STAFF RECOMMENDATION
924 McFerrin Avenue
September 18, 2019

Application: New Construction—Addition; Partial Demolition
District: Greenwood Neighborhood Conservation Zoning Overlay
Council District: 05
Base Zoning: MUN-A
Map and Parcel Number: 08208010600
Applicant: Wendy Cheney
Project Lead: Melissa Sajid, melissa.sajid@nashville.gov

<p>Description of Project: This application is to construct a rear addition to the contributing building.</p> <p>Recommendation Summary: Staff recommends approval of the application with the conditions:</p> <ol style="list-style-type: none">1. The covered portion of the deck shall be at least twenty feet (20') from the existing outbuilding;2. Staff approve all materials prior to purchase and installation;3. The sides of the pergola shall not be covered with temporary or permanent walls without review; and4. The HVAC shall be located behind the house or on either side, beyond the midpoint of the house, and utility meters shall be located on the side of the building, within 5' of the front corner or on the rear or rear-side within 5' of the rear corner. Alternative mechanical and utility locations must be approved prior to an administrative sign-off on

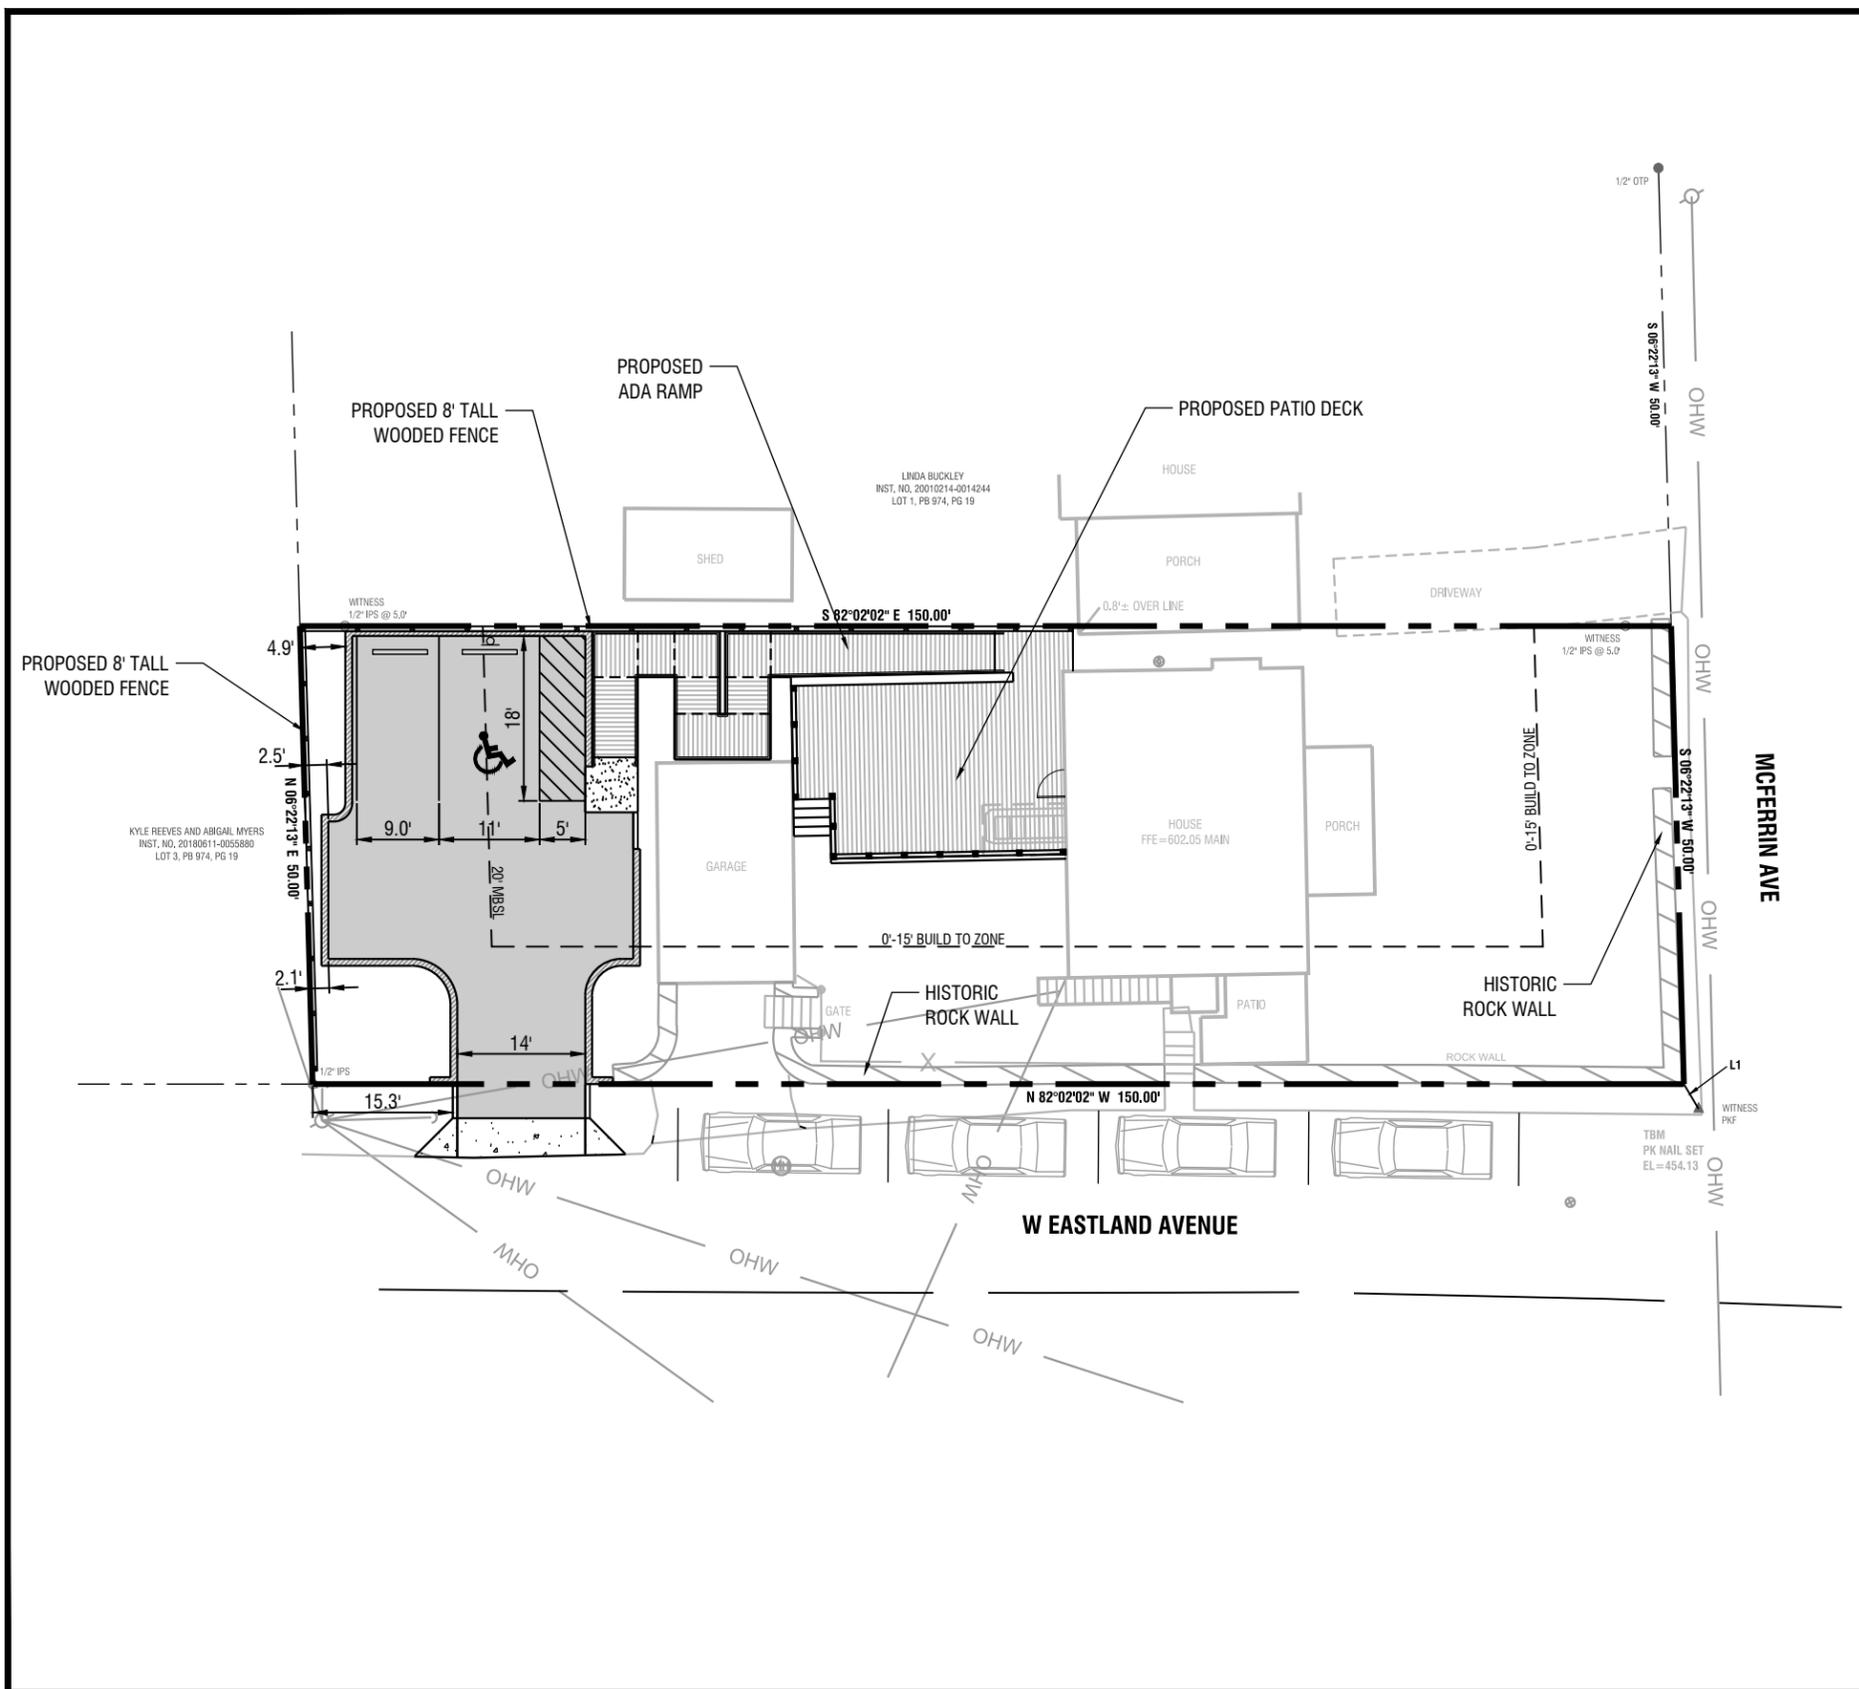
Appurtenances & Utilities: The plan includes the addition of on-site parking at the rear of the site and a handicapped ramp along the interior side property line. An eight foot (8') tall fence is proposed along the rear and right-side property line at the rear of the house. The historic stone wall along the front and left-side property line along West Eastland Avenue will be retained.

The location of the HVAC and other utilities was also not noted. Staff recommends that the HVAC shall be located behind the house or on either side, beyond the midpoint of the house, and utility meters shall be located on the sides or rear of the building. Alternative mechanical and utility locations must be approved prior to an administrative sign-off on building permit(s).

1. The covered portion of the deck shall be at least twenty feet (20') from the existing outbuilding;
2. Staff approve all materials prior to purchase and installation;
3. The sides of the pergola shall not be covered with temporary or permanent walls without review; and
4. The HVAC shall be located behind the house or on either side, beyond the midpoint of the house, and utility meters shall be located on the side of the building, within 5' of the front corner or on the rear or rear-side within 5' of the rear corner. Alternative mechanical and utility locations must be approved prior to an administrative sign-off on building permit(s).

2 PROPOSED BACK ELEVATION
1/4" = 1'-0"

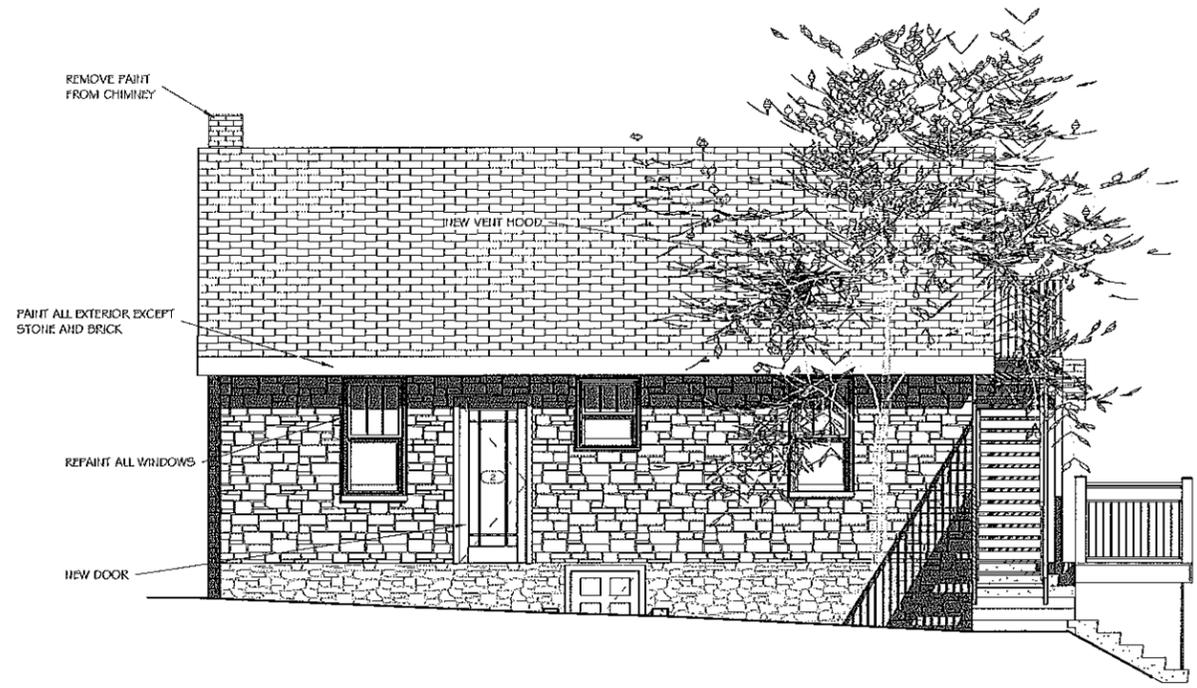
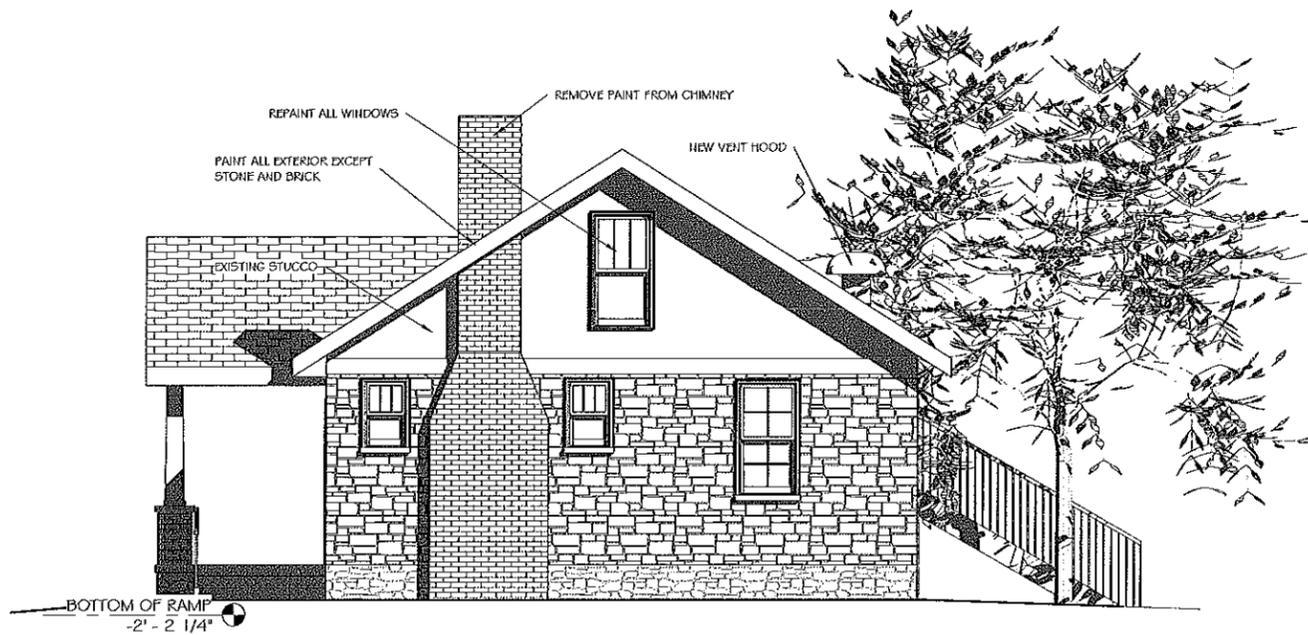
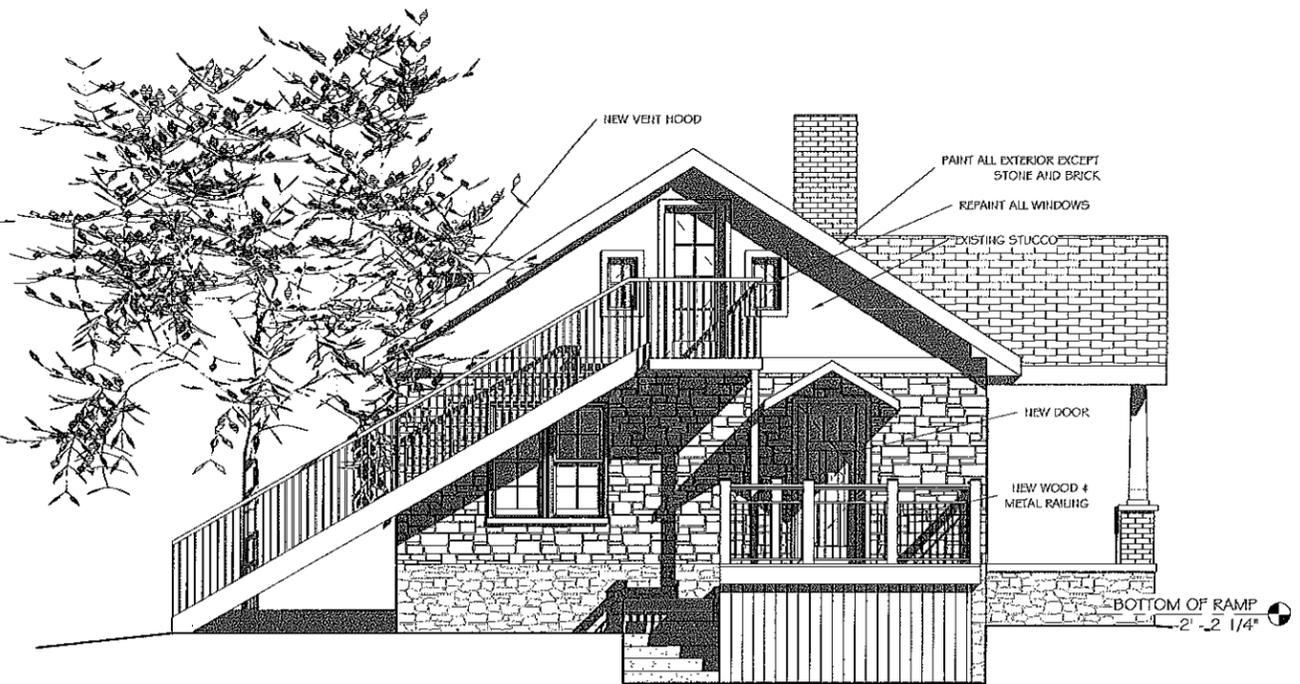
Height & Scale: The covered pergola is situated at the rear of the historic structure and is single-story with a height of approximately ten feet, six inches (10'-6"). As proposed, the addition is neither taller nor wider than the historic building and does not more than double the footprint or depth. The addition adds approximately five hundred six square feet (506 sq. ft.) and twenty-three feet, nine inches (23'-9") in depth to an historic structure with an existing footprint of nine hundred seventy square feet (970 sq. ft.) and thirty-three feet (33') of depth. Staff finds that the addition's height and scale meet the design guidelines.

Design, Location & Removability: The plan proposes a rear deck that will be covered with a pergola. As proposed the pergola is situated at the rear of the historic building and is inset one foot (1') from the right rear corner and fourteen feet (14') from the left rear corner. The pergola itself will not be attached to the historic structure. However, the covered deck will be constructed on top of a foundation wall that will be extended from the historic structure. The proposed foundation line will match that of the historic building.

While the pergola is proposed to be open on both sides, a masonry wall is proposed to be constructed next to the deck on the right side. The masonry wall will be approximately seven feet, one inch (7'-1") tall and will not attach directly to the historic structure. It will also not impact the existing historic stone wall or fencing along the interior side or rear property lines. As proposed, it will be connected to the historic building by a gate that is approximately four feet, nine inches (4'-9") wide. Typically, fencing and walls are not reviewed in conservation overlays, but the proposed wall is part of the addition. For fencing in side and rear yards, zoning allows the height to be up to eight feet (8') tall. Staff finds the proposed wall to be appropriate since it is located within the interior side yard and is not attached to the historic building.

Roof form: The pergola will have a flat roof that is typical of pergolas. Staff finds that the proposed roof form meets Section II.B.1.e.
